TO: Madeleine Reinke, Kimley-Horn and Associates, Inc.
FROM: Cynthia Thye, Planner 1
DATE: December 31, 2025
SUBJECT: SP25-119: Lincoln Professional Park L2 - 7 Brews Coffee – Site Plan
Review Comments 02

LINCOLN PROFESSIONAL PARK FILING NO. 1
LOT 2, PARKER, CO
7 BREW - SITE PLAN
COVERSHEET

LINCOLN PROFESSIONAL PARK FILING NO. 1
LOT 2, PARKER, CO
7 BREW - SITE PLAN
SITE PLAN

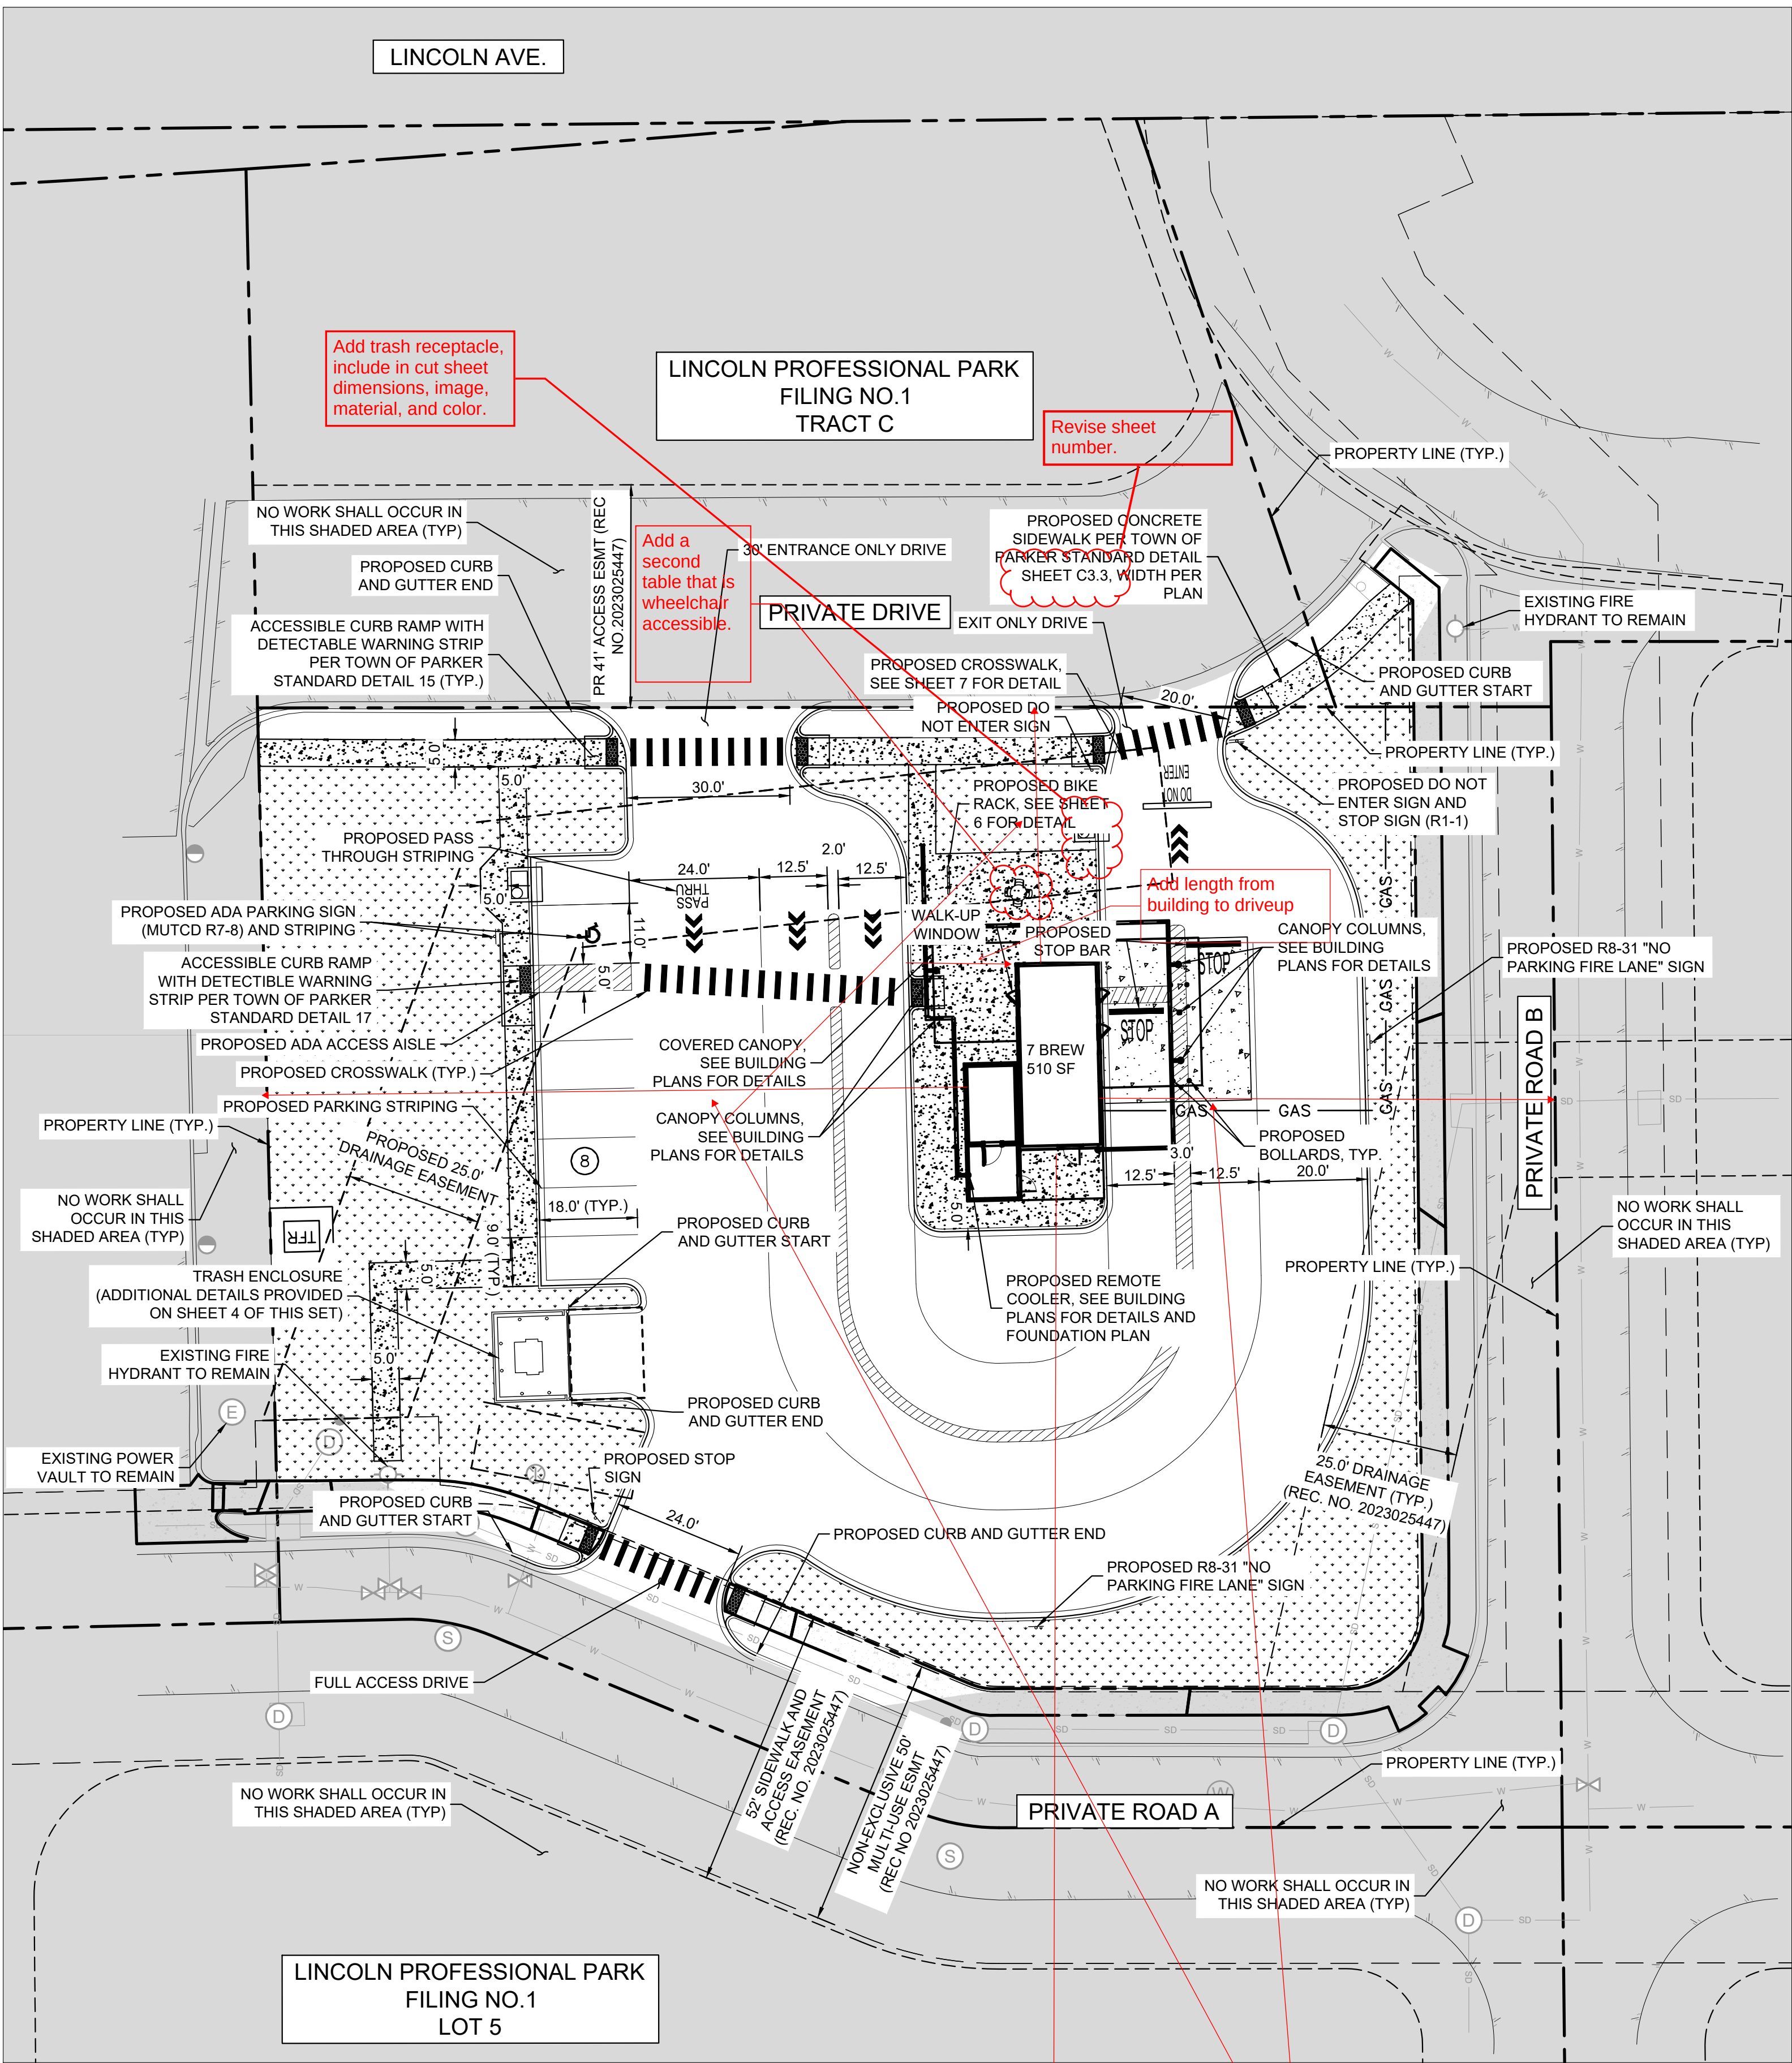
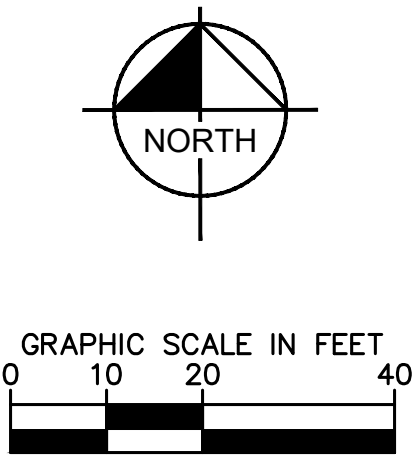
Add legend for hardscaped surfaces and materials.

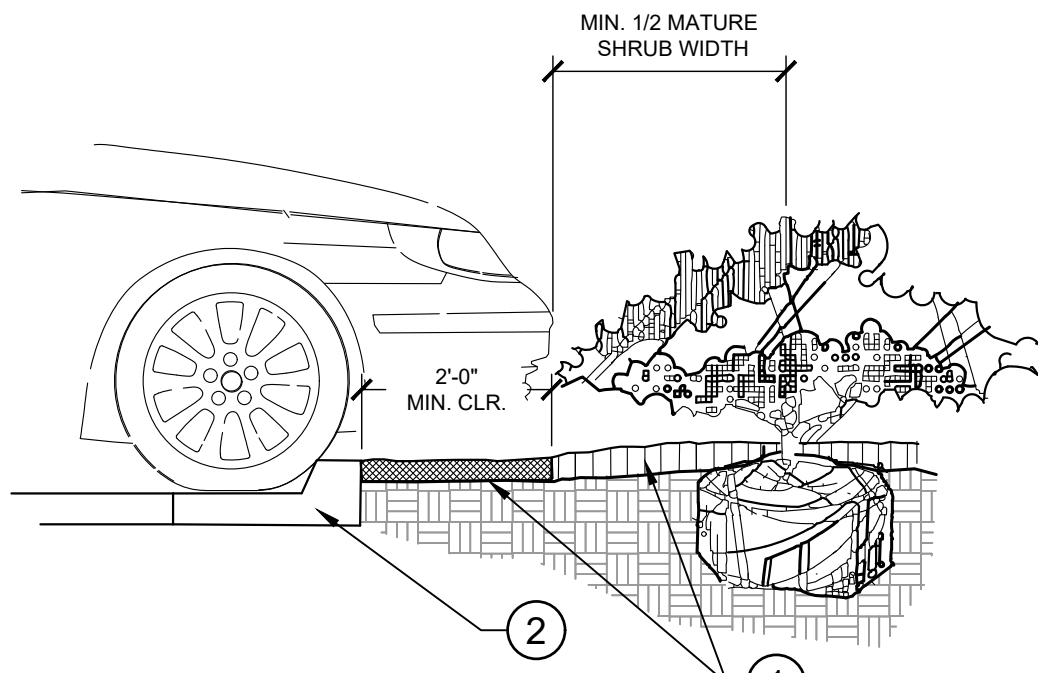
These are not correct.
Recalculate.

Add: P1 (this is a min.
six foot area per LDO
13.08.090(g)(4).

Revise - in Mixed Use Community - tree per 40 linear feet.

Per LDO 13.08.090(h)
Add Site Interior Landscaping
category if parking lot and perimeter
landscaping do not collectively meet
min. landscaping requirement.

1 EXTERIOR ELEVATION - SOUTH
3/8" = 1'-0"

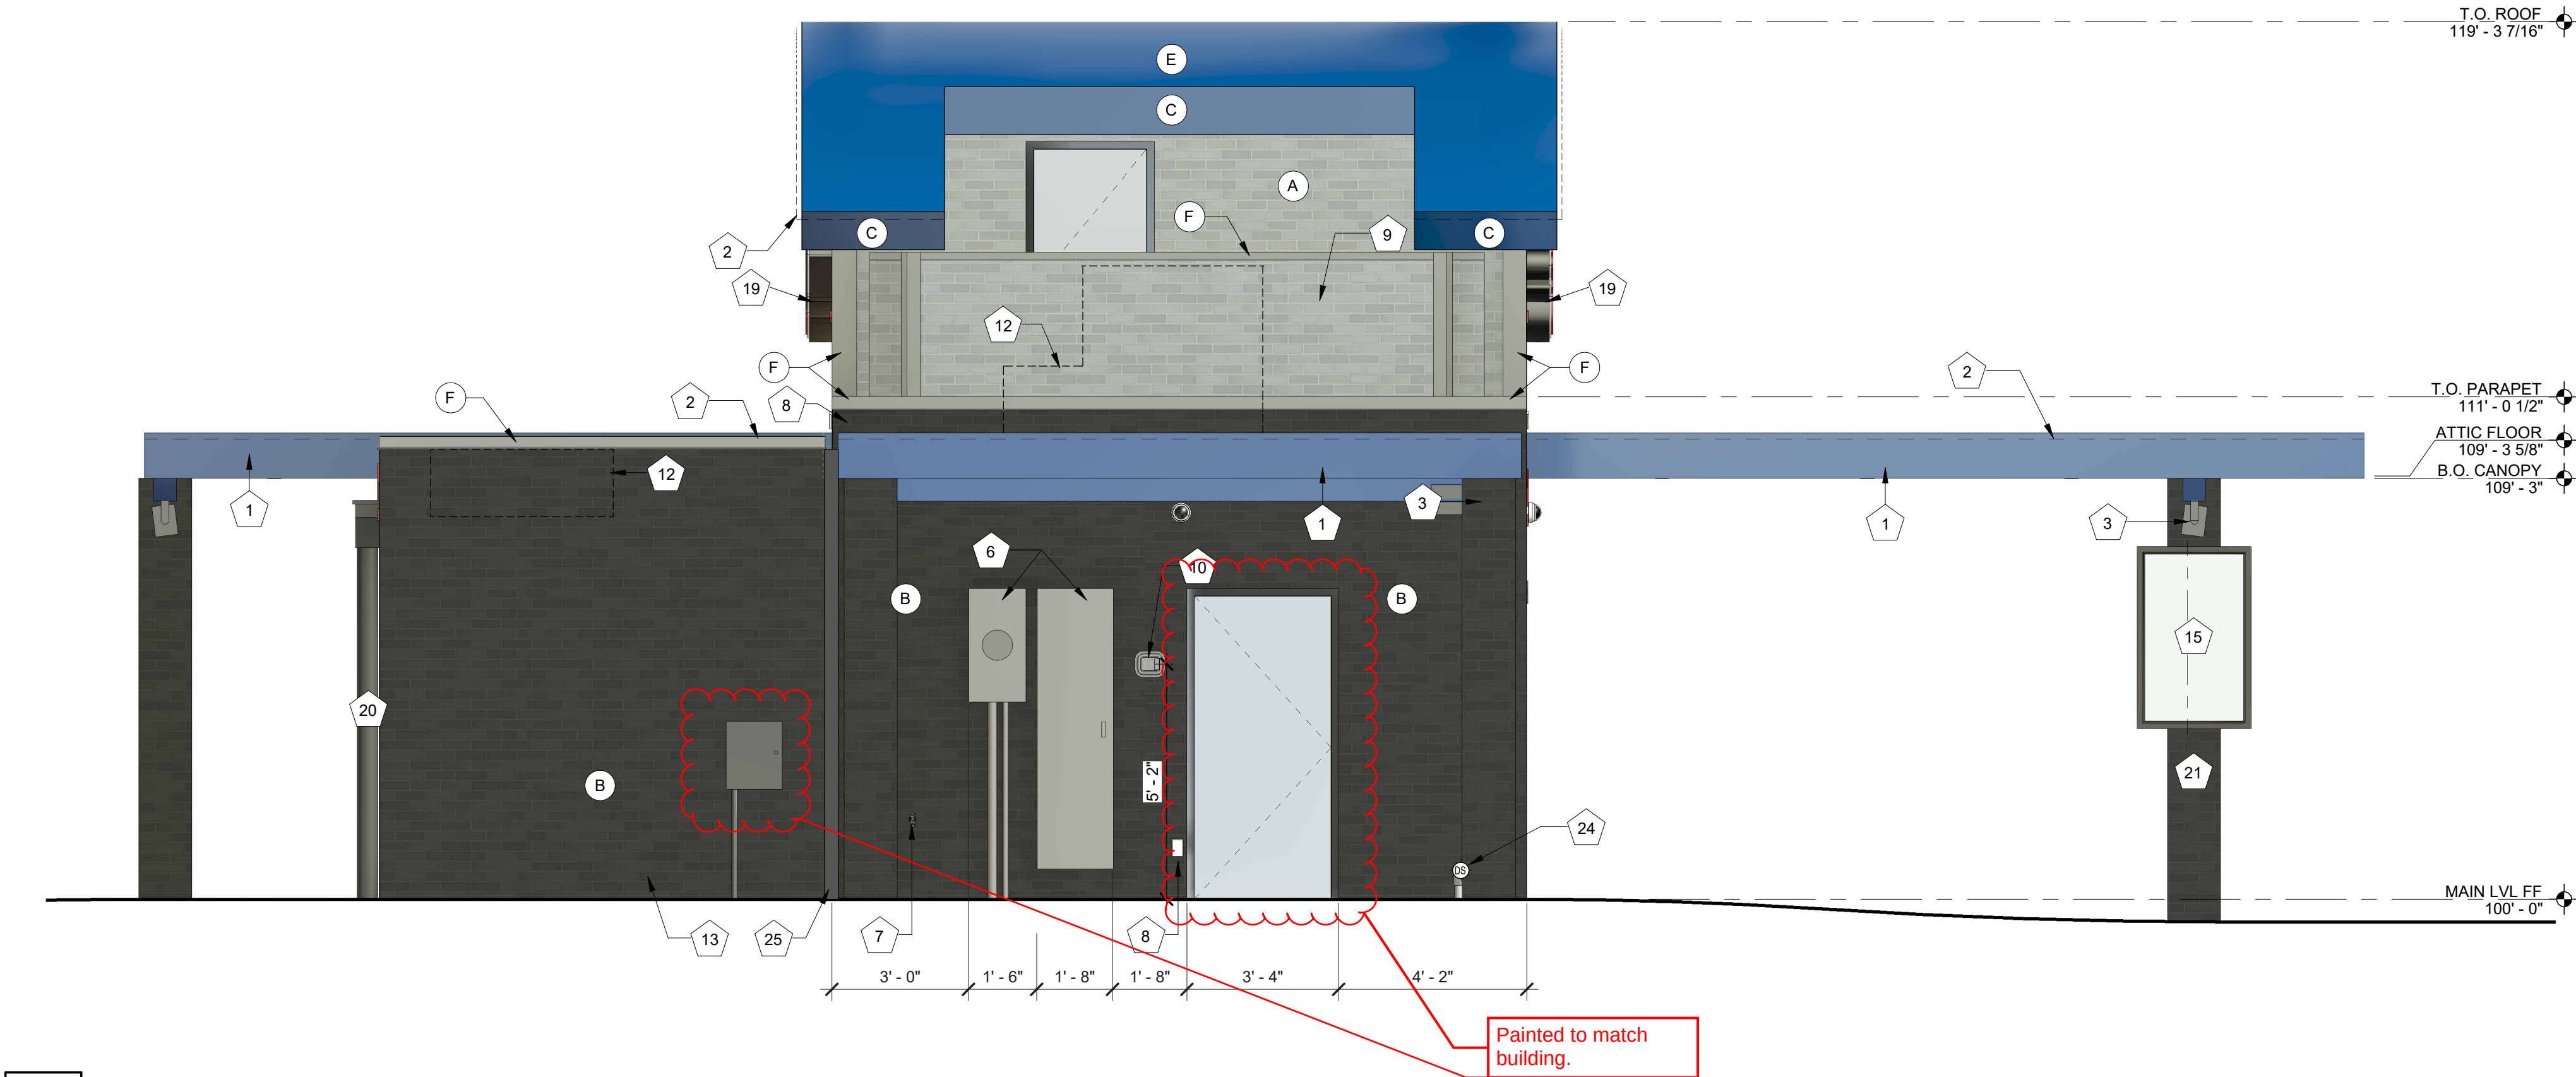
Add percent of each material.

Add Glass to Legend

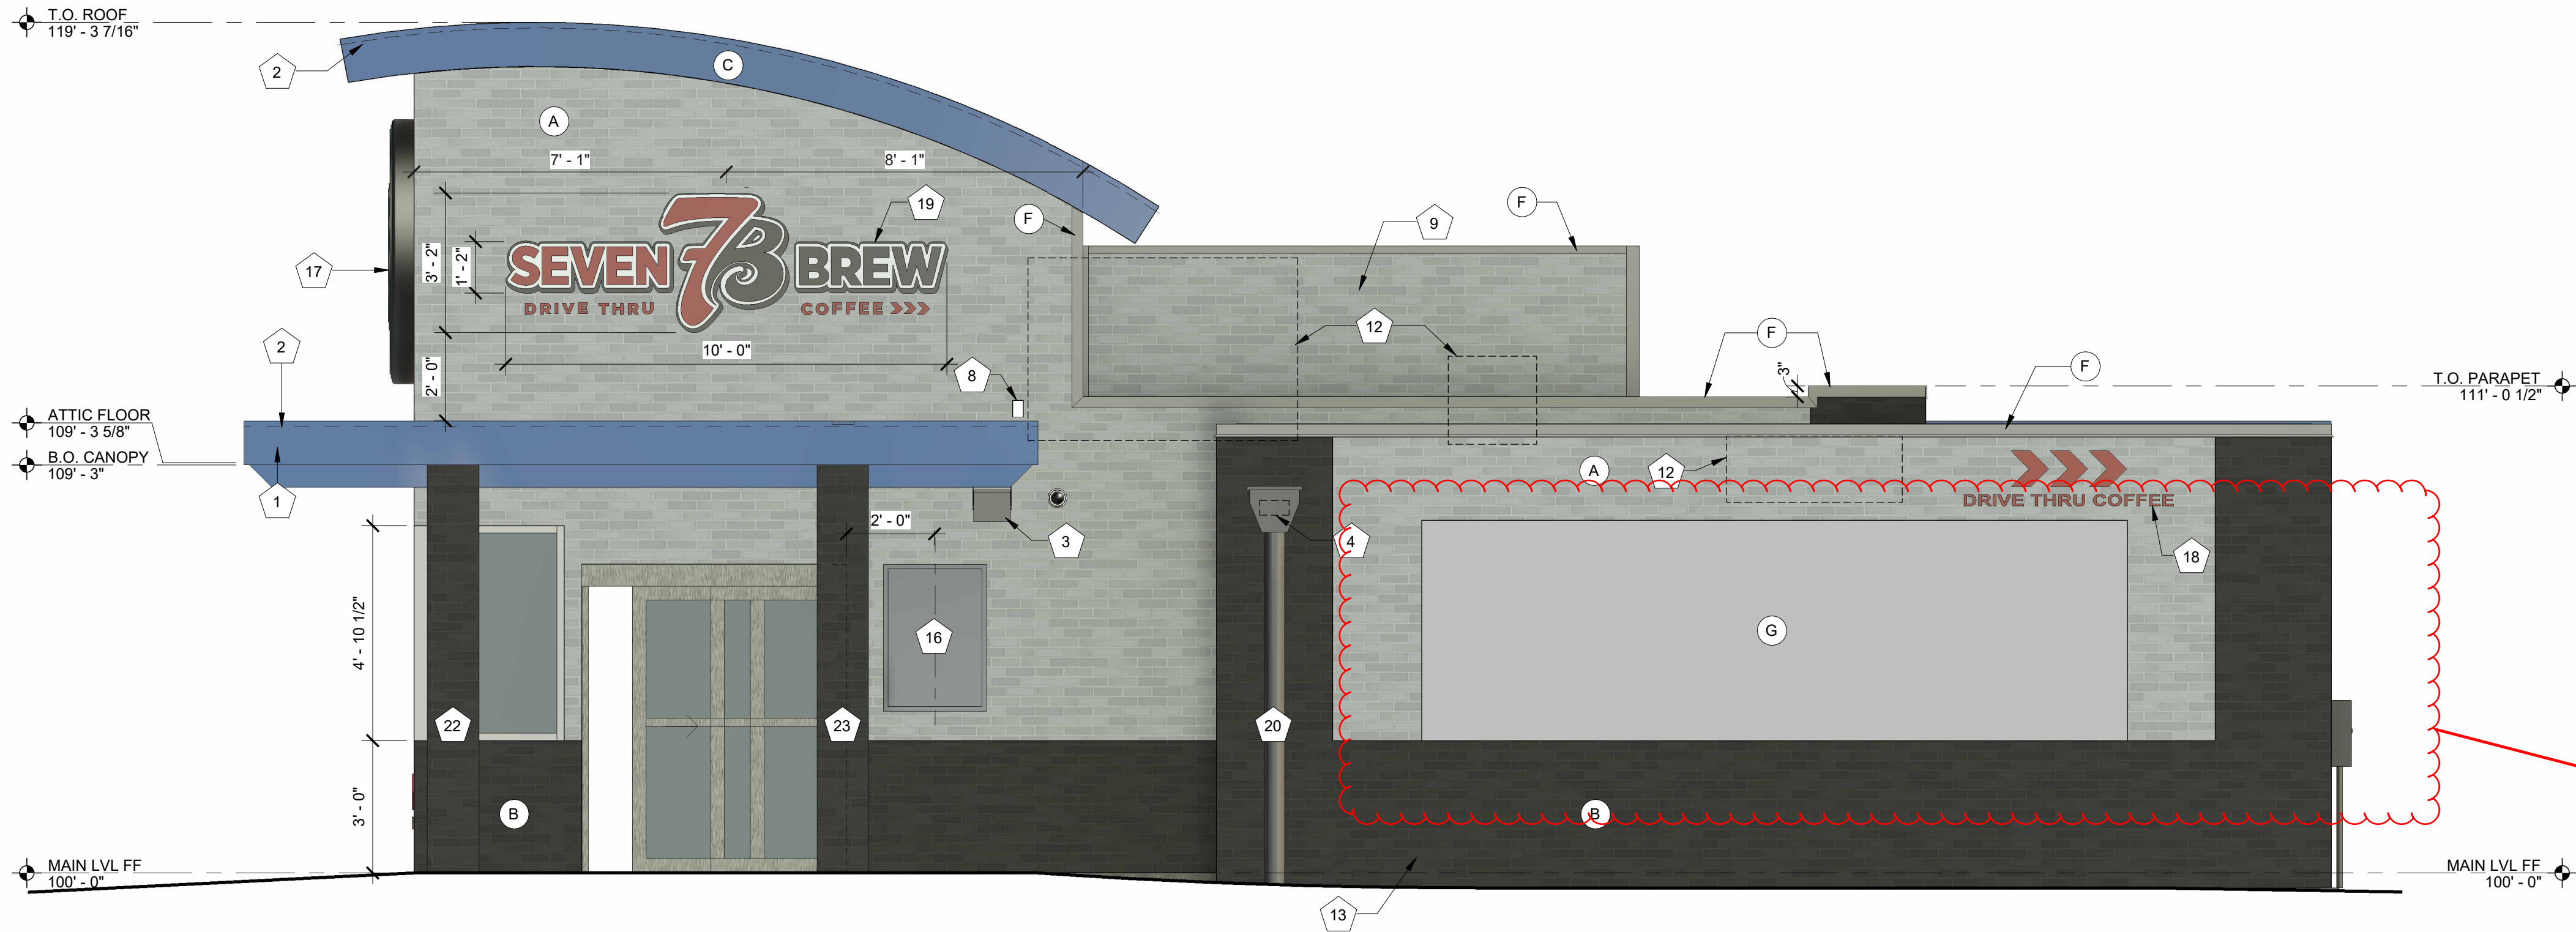
Provide an image of the proposed mural. It cannot be "logo art" of Seven Brew nor lettering, nor coffee image.
